Docket Number:	19-BSTD-03
Project Title:	2022 Energy Code Pre-Rulemaking
TN #:	235021
Document Title:	Jim Marsh, Munters Data Centers Comments - Support Increased Temperature Threshold for Economizers and Recommend Add Integrated Refrigerant Economizer to Prescriptive
Description:	N/A
Filer:	System
Organization:	Jim Marsh, Munters Data Centers
Submitter Role:	Public
Submission Date:	10/5/2020 2:22:48 PM
Docketed Date:	10/5/2020

**Support Increased Temperature Threshold for Economizers and
Recommend Add Integrated Refrigerant Economizer to Prescriptive**

Document Title: *CASE Report Nonresidential Computer Room Efficiency*

Statement in Support of *CASE Report Nonresidential Computer Room Efficiency Code Change Recommendations, Specific to 1. Increased Temperature Threshold for Economizers*

Reference Graph

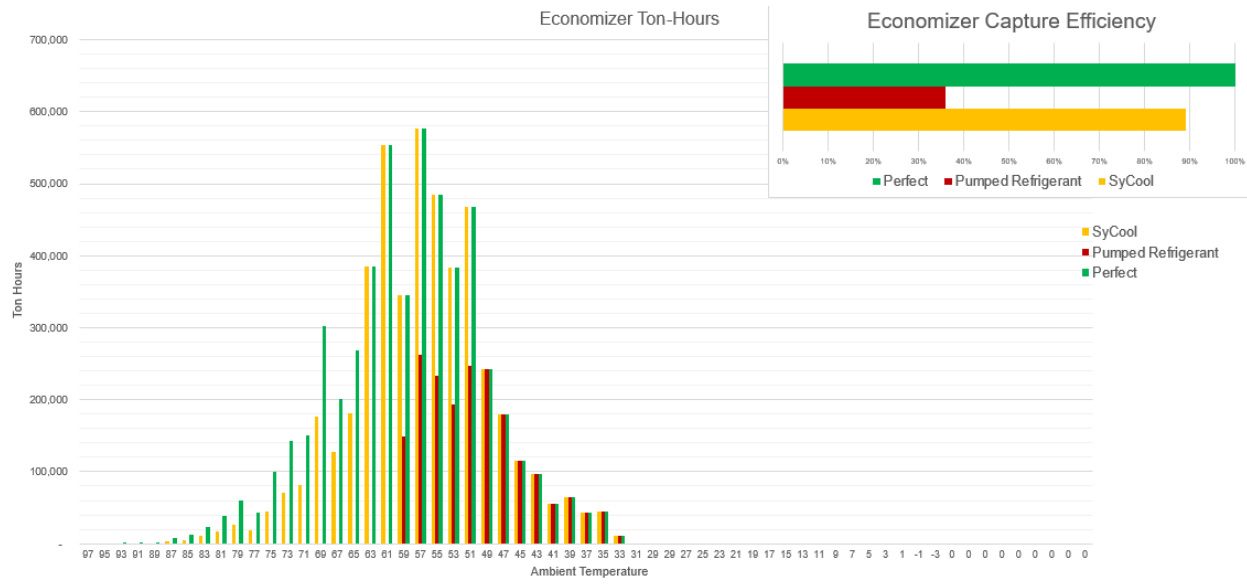
Ton-hours per bin temperature graph: Munters SyCool thermosyphon refrigerant economizer capture efficiency (yellow) compared with perfect – 100% economization/year (green) and integrated pumped refrigerant economizer (red), based on San Jose, 75°F SAT / 95°F RAT, 80% load, no evaporative assist. Pumped refrigerant data: <https://www.vertiv.com/en-us/support/tools-applications/free-cooling-economizer-calculator/>, Model DA 150

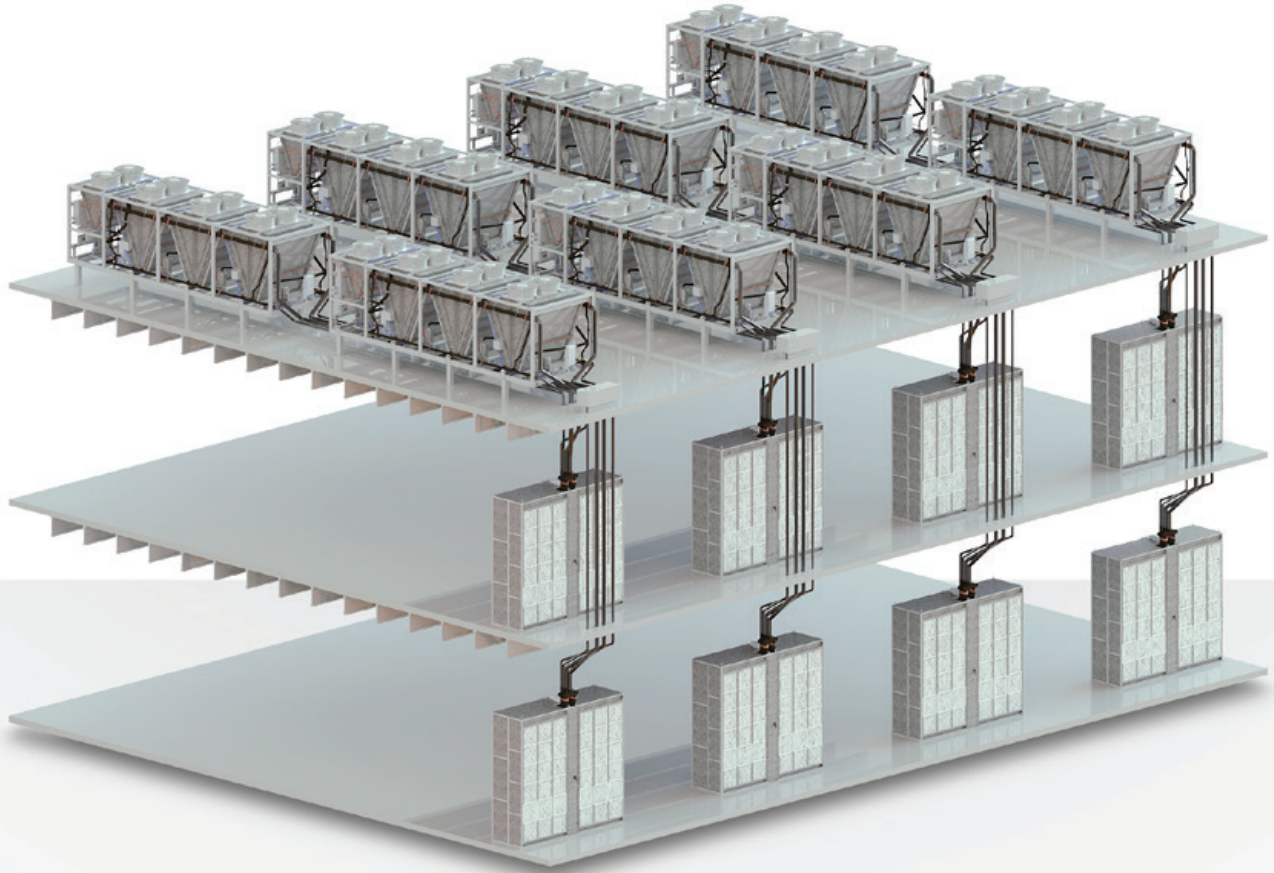
Market feedback tells us that data centers rarely if ever have 100% critical IT load actually installed and operating. The industry has recently standardized on tracking part load operational levels of 75%, 50%, and 25% critical IT load metrics. These variations can have profound effects on full economization threshold and economization effectiveness.

There is an equivalency to normal operation compared with operating at full critical load at N with all units running at part load, e.g. a system designed $N = 1$ with $N+1$ redundancy, 100% IT load will require all systems during normal operation at 50% of capacity, $N = 2$ with $N+1$ redundancy system operation at 66% capacity, etc.

Combining normal operation with IT part load results in cascaded capacity reduction, e.g. $N = 4$ with $N+1$ redundancy and 75% IT load will require all systems during normal operation at 60% capacity.

We recommend clarification of baseline definition for critical IT load and redundancy used in rating economizer performance and to include part load economization performance metrics in line with ANSI/ASHRAE Standard 90.4 – 2019, 6.5 *Maximum Annualized Mechanical Load Component (MLC)* for comparison of economizer strategies.
